CITY OF West Linn

STAFF REPORT FOR THE PLANNING COMMISSION

FILE NUMBER: DR-23-01

REQUEST: The applicant is requesting approval for the demolition of two existing structures, to be replaced with a three-story commercial building with underground parking at 1919 and 1949 Willamette Falls Drive.

1 GROUND FLOOR PLAN + WILLAMETTE FALLS DRIVE ELEVATION

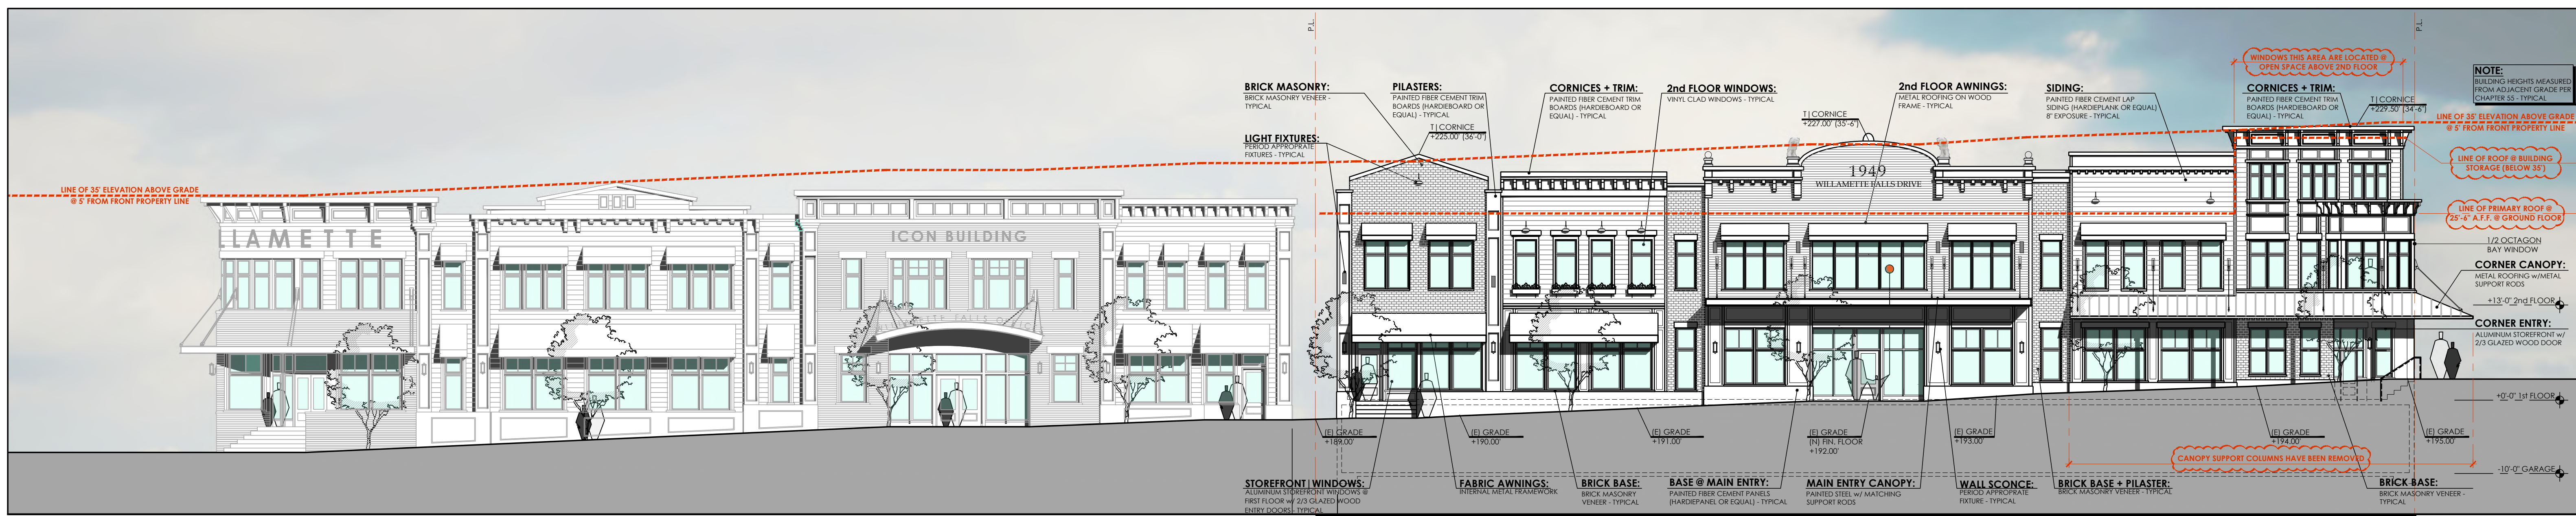
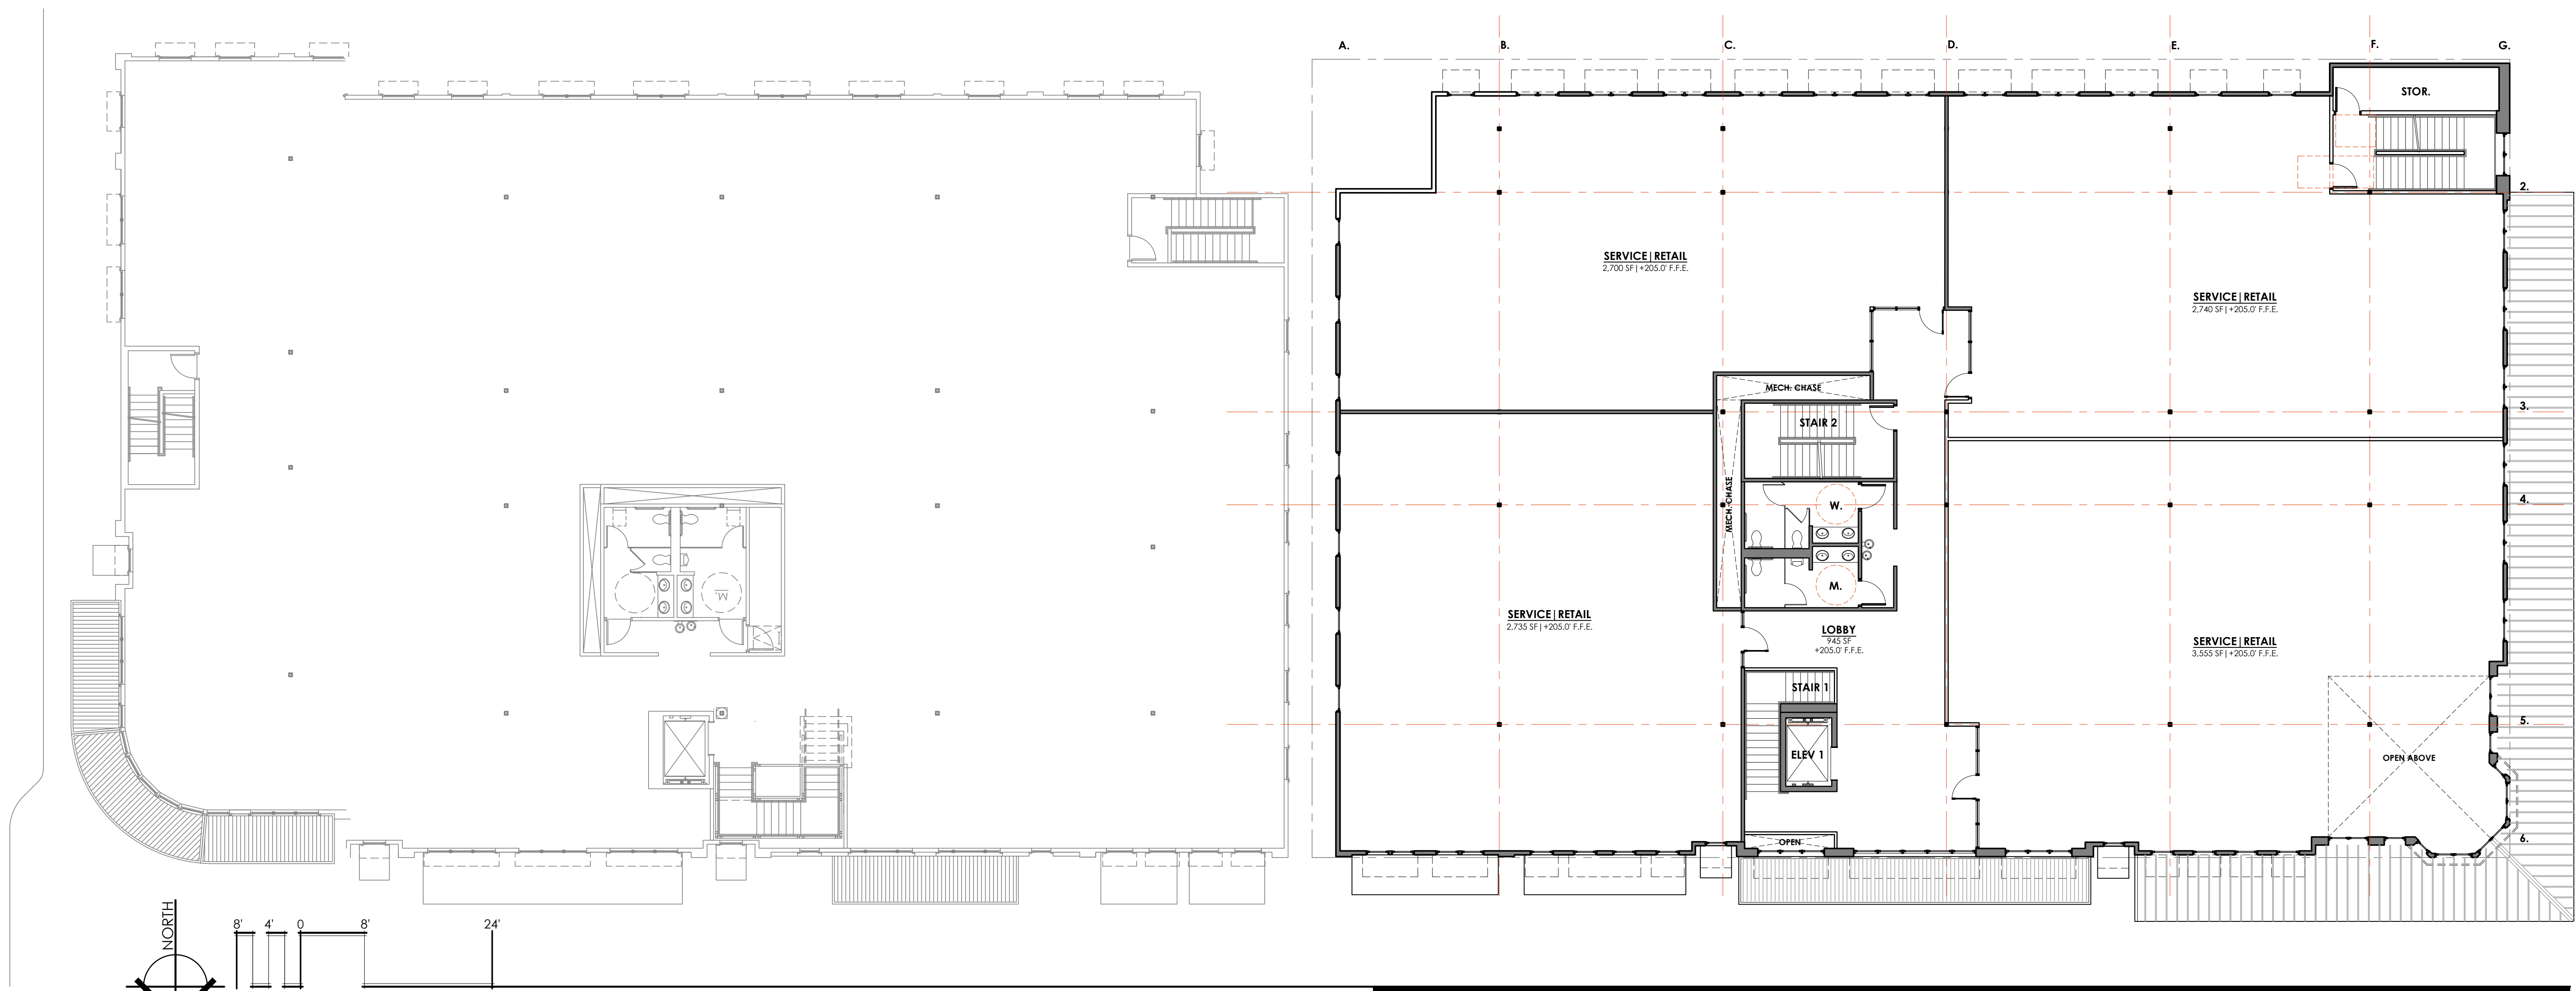
6. **Vertical Breaks.** Prior to issuance of building permits, the applicant shall submit building permit plans with revised western and southern elevations that demonstrate compliance with CDC 58.080.C.7 that requires strong vertical breaks or lines regularly spaced every 25 to 50 feet.

The longest façade plane along Willamette Falls Drive without a vertical break is approximately 45 feet per the conceptual elevations in PC-1. As the primary façade, this is where the variation is most important for maintaining streetscape continuity. Side and rear elevations exceed this standard at 58 feet on the western façade facing 12th street, and 83 feet facing Knapps Alley. To ensure compliance with this standard, a condition of approval has been added requiring the submission of revised plans at the building permit stage that demonstrate compliance with this standard. As conditioned, this standard will be met.
